HVAC Findings

Prepared by David Annan

Sep 17, 2024

IMG_5354
David Annan
Sep 17, 2024 5:26 PM

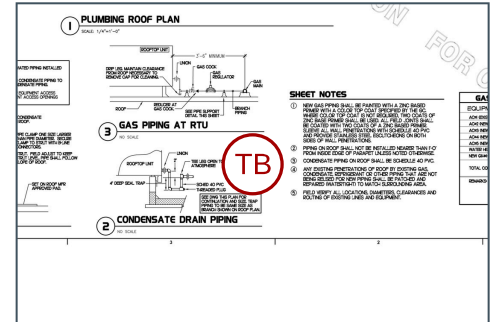
#302 Condensate drains only have 1 union

All condensates drains for the RTUs only have 1 union. The plans show 2 unions between the P-traps. Refer to page P3.1 "detail 2" for specifications.
